**James City County Environmental Division  
Stormwater Management/BMP Record Drawing &  
Construction Certification Review  
Tracking Form**

Project Name: Williamsburg Wicker Expansion  
 County Plan No.: SP-074-08  
 Stormwater Management Facility: Bioretention  
 BMP Phase #:  I  II  III  
 Information Package Received. Date/By: 5/6/10  
 Completeness Check:  
 Record Drawing Date/By: 5/6/10 AES  
 Construction Certification Date/By: 5/6/10 AES  
 RD/CC Standard Forms (Required for all BMPs after Feb 1<sup>st</sup> 2001 Only)  
 Insp/Maint Agreement # / Date: 5/27/09 Sheet 5-App Plan SP07408  
 BMP Maintenance Plan Location: \_\_\_\_\_  
 Other: \_\_\_\_\_  
 Standard E&SC Note on Approved Plan Requiring RD/CC or County comment in plan review  
 Yes  No Location: Sheet 4-SP-074-08  
 Assign County BMP ID Code #: Code: YC058  
 Preliminary Input/Log into Division's "As-Built Tracking Log"  
 Add Location to GIS Map. Obtain basic site information (GPIN, Owner, Address, etc.)  
 Preliminary Log into Access Database (BMP ID #, Plan No., GPIN, Project Name, etc.)

BIORETENTION POND RECORD DRAWING  
WILLIAMSBURG WICKER EXPANSION PHASE I

# SITE PLAN FOR WILLIAMSBURG WICKER EXPANSION

GRADING AND EROSION CONTROL PLAN  
WILLIAMSBURG WICKER EXPANSION  
PHASE I

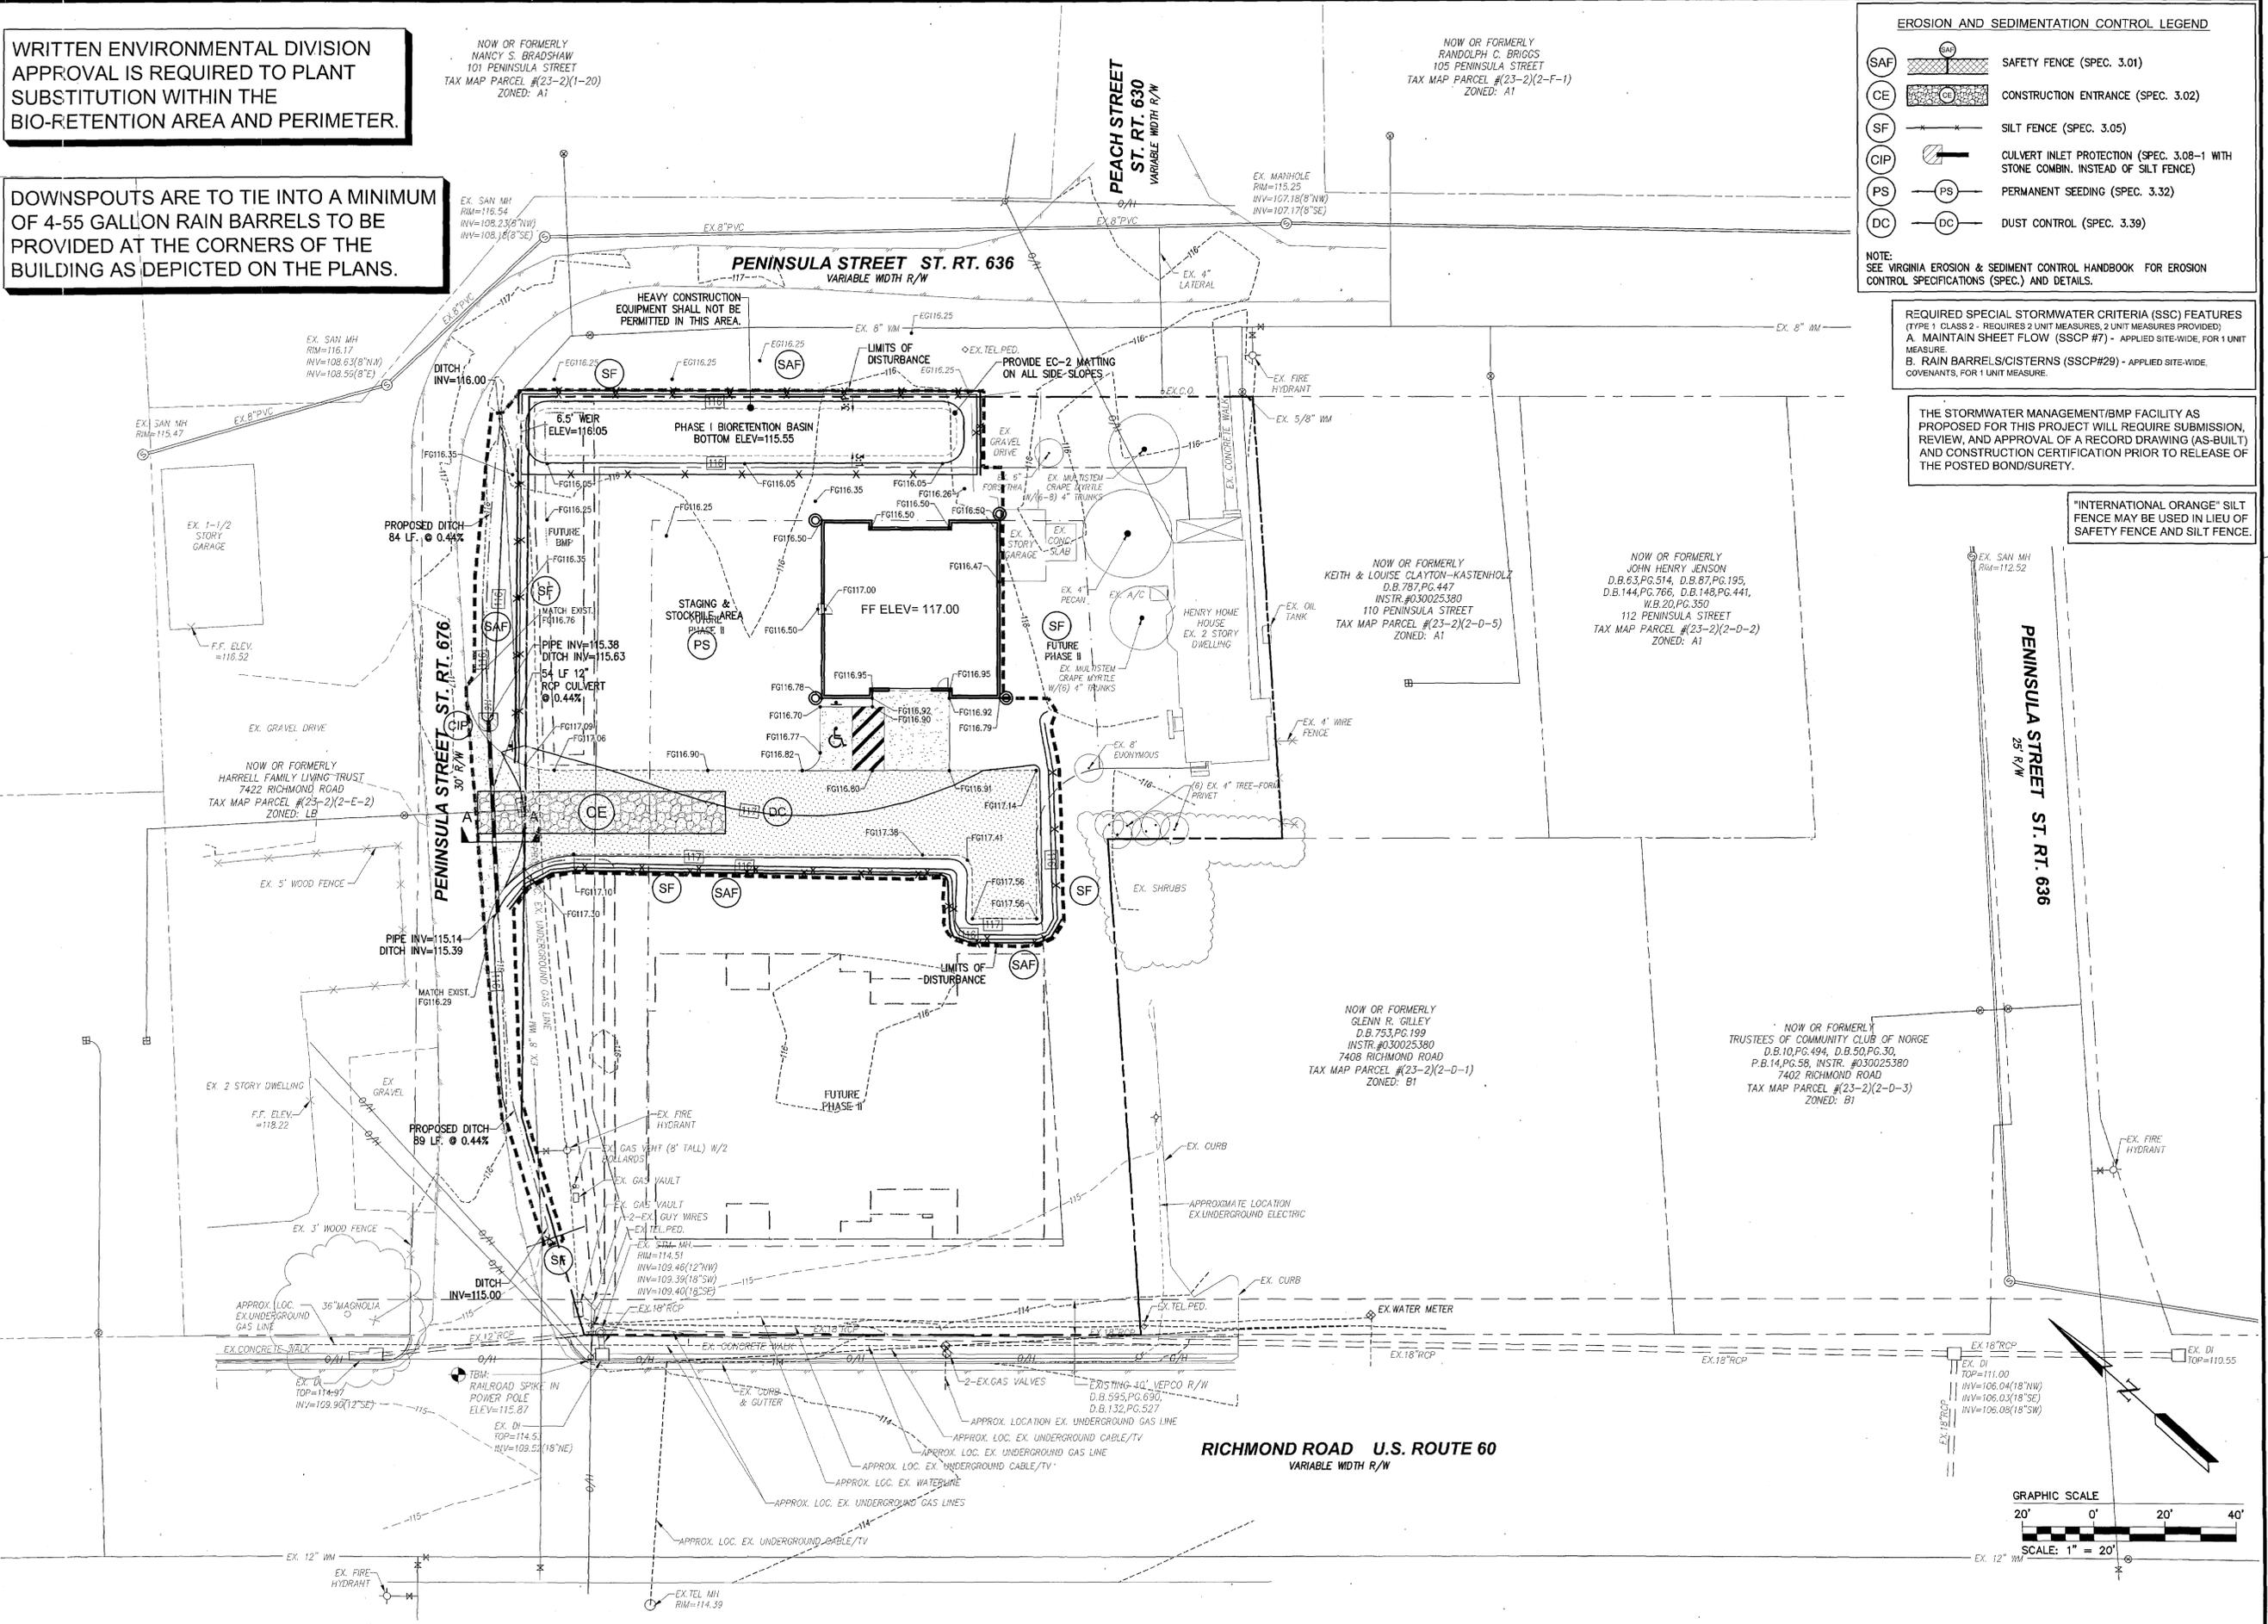
**Response:** The existing and proposed contours are shown and labeled on the Grading, Drainage, and Erosion & Sediment Control Plan sheet 4.
